**Subject: MHI's Amended Response to US-APWR DCD RAI No. 374-2446 Revision 0
(SRP 03.09.05)**

**Amended Response to Request for Additional Information
No. 374-2446 Revision 0**

**RAI NO.: NO. 374-2446 REVISION 0
SRP SECTION: 3.9.5 – REACTOR PRESSURE VESSEL INTERNALS
APPLICATION SECTION: 03.09.05
DATE OF RAI ISSUE: 5/21/2009**

QUESTION NO.: 03.09.05-10

Figure 3.9-9 Neutron Reflectors

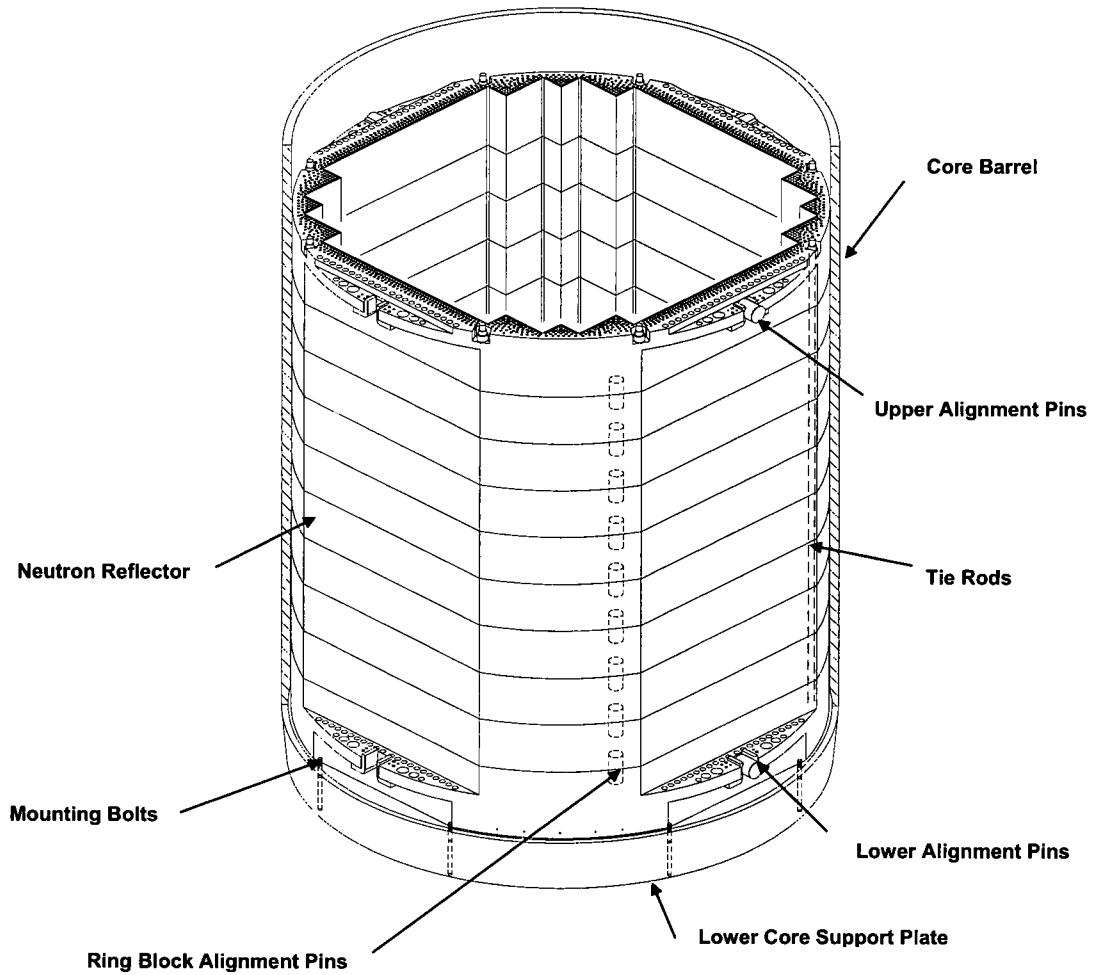
The DCD Tier 2, Subsection 3.9.5.3.4 includes the potential effects of irradiation stress relaxation in the list of environmental effects on reactor core internal materials caused by long term exposure to fast neutron irradiation. The applicant stated that neutron fluence and temperature limits are imposed on the tie-rods to preclude excessive loss of preload from irradiation stress relaxation.

design of currently operating PWR plants. The neutron reflector consists of multiple stacked ring blocks that ~~which are supported~~ mounted on the lower core support plate in the vertical downward direction by the lower core support plate and by tie rods and neutron reflector mounting bolts in the vertically upward direction.

Vertical restraint for upward mechanical loads is provided by tie-rods and neutron reflector mounting bolts. The tie-rods are captured by a nut bearing on the top ring block. The tie-rods pass through holes in the blocks and are threaded into the lower core support plate. Fluence and temperature limits are also imposed on the tie-rods to preclude excessive loss of pre-load from irradiation relaxation. In addition, the bottom ring block is fastened directly to the lower core support plate by the mounting bolts. Ring blocks, excluding the bottom ring block, can be held down by their own weight in normal operating conditions, including design transients. During seismic and LOCA events, the lift-off displacement is restricted by the tie rods.

Figure 3.9-10 Fasteners around the Core

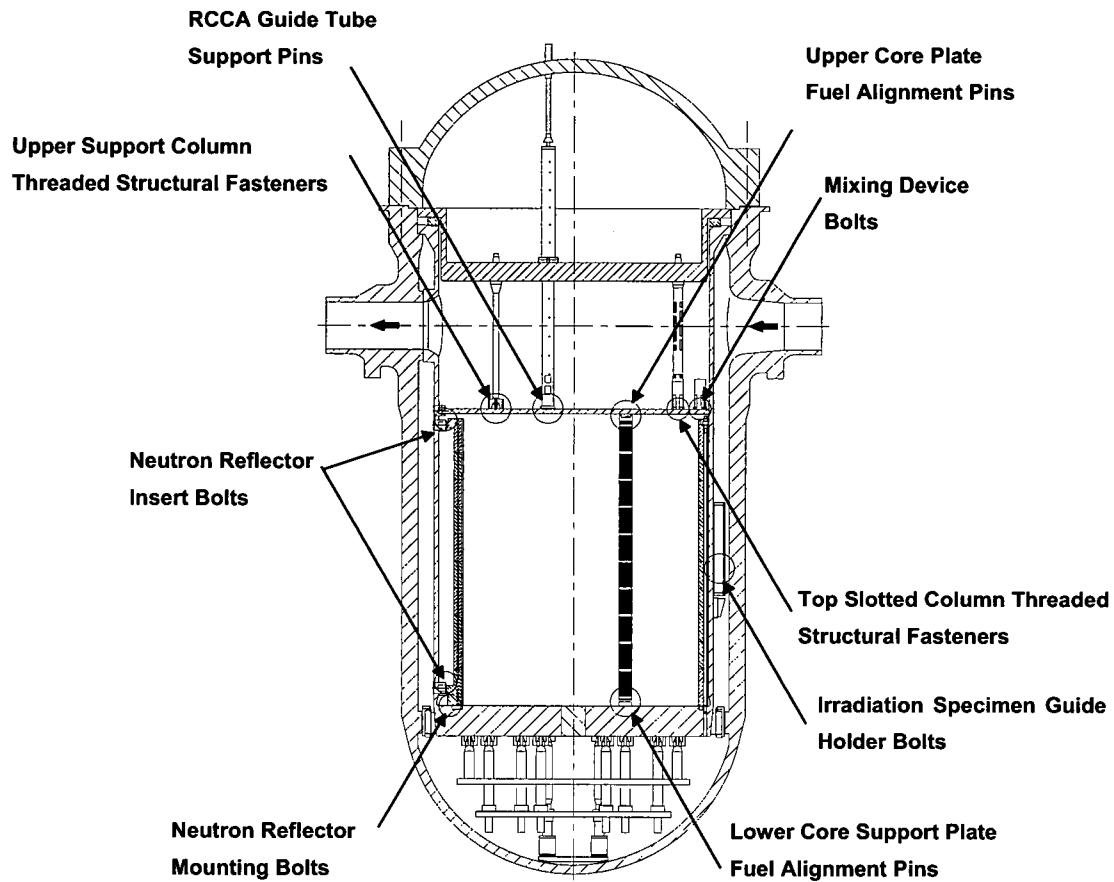
The staff reviewed the DCD but did not find where the applicant had provided an evaluation of the loss of preload in various threaded fasteners due to irradiation stress relaxation or a reference where this information is available. The applicant did not identify the fasteners where the effect of irradiation stress relaxation is expected to be significant. Also, it is not clear how the pre-stress will be maintained in the preloaded components such as the ring block tie-rods or guide tube hold-down bolts. The applicant is requested to provide an assessment of the potential loss of preload due to irradiation stress relaxation in various threaded fasteners, in particular the guide tube hold-down bolts, guide tube support pins and the flexible leaves, and the neutron reflector tie-rods, and examine its effect on the structural and functional integrity of the components. Alternately, provide a reference document where this information is available. The requested information will assure conformance with GDC-1 and 4. Revise the DCD to include the requested information or provide a reference where this information is available.

2. The neutron doses on various threaded fasteners are much smaller than those on the neutron reflector tie rod, and the potential loss of preload tension is small.

Another environmental effect from fast neutron exposure on reactor internals is irradiation stress relaxation of threaded fasteners. The fasteners used near the core are identified in Figure 3.9-10 and have much smaller neutron doses than those on the neutron reflector tie rod. Tie rods restrain the US-APWR neutron reflector's vertical lift-off displacement is fastened axially during seismic and LOCA events and are made by tie rods of strain hardened 316 stainless steel. Preloaded tension on the tie rod is reduced as a result of irradiation generated during normal plant operation. Because of this, the tie rod is designed to ensure that some preload is left at the end of a 60 year plant life in order to ensure that its functional requirements are met. The neutron dose on the tie rod is comparable to that of the neutron reflector ring block and is minimized by locating the tie rods near the outside of the neutron reflector.
